Technical Memo

To: Suzanne Barker, Colac Otway Shire
From: Peter Van Wyk, Senior Engineer Network Planning, Barwon Water
Date: 30 January 2018
Subject: Armstrong & Hearn Streets Colac – Draft Development Plan

Figure 2: Draft Development Plan

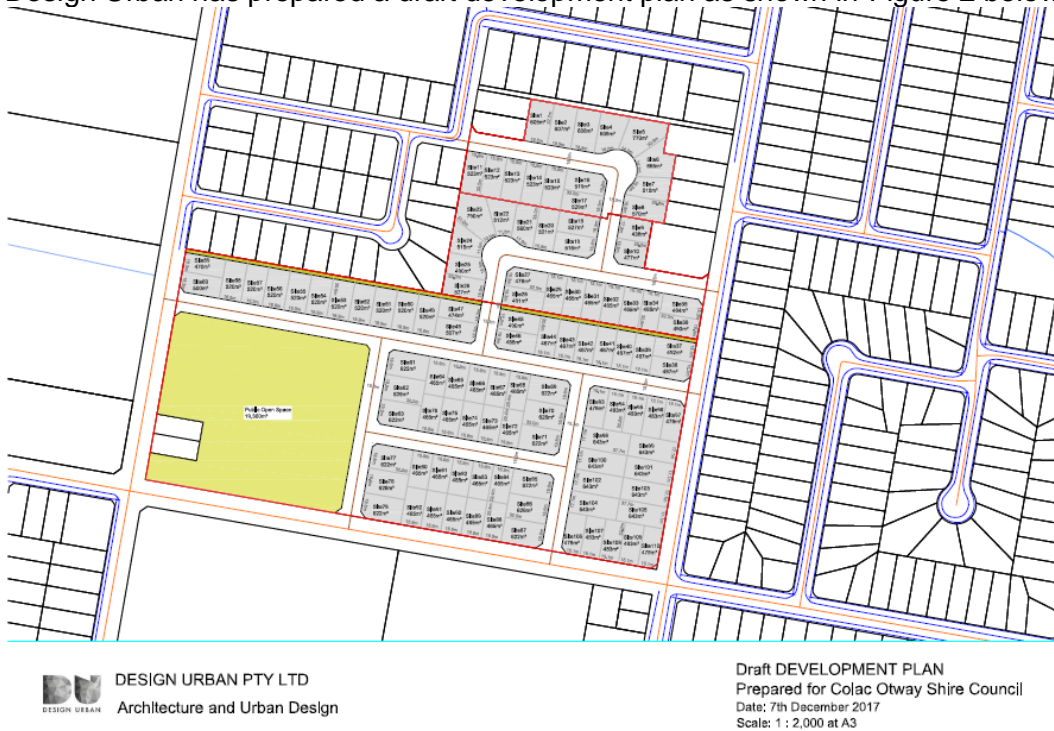
The site naturally falls to the south-west and a number of sewers adjoin the area as shown by blue lines in Figure 3 below. All sewers have adequate capacity to service the adjacent proposed development.

Given that a LSIO and FO are proposed, Barwon Water will have to review the implication of this on its land when further developing the site for a future sewerage detention storage.

Figure 4: Water main layout

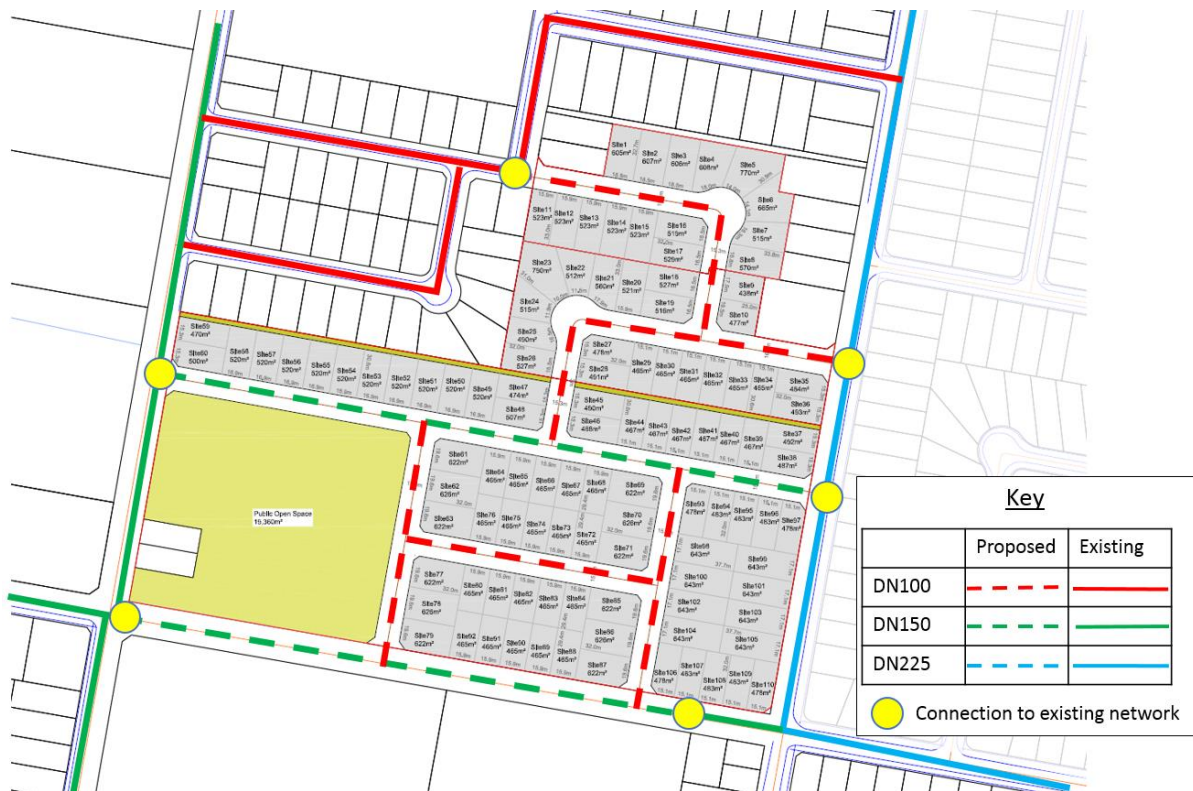
The proposed development area near Hearn and Armstrong Street in Colac will connect to the Colac Urban PMA (Pressure Management Area) water pressure zone. This pressure zone can supply water up to the 150 m contour. The subject development site falls between the 125-132 m contours.

The lots within the development shall be supplied via mains constructed in accordance with *Figure* . The lots fronting Armstrong St, Hearn St & Sinclair St can be supplied with tapplings from the DN225, DN150 & DN150 respectively.
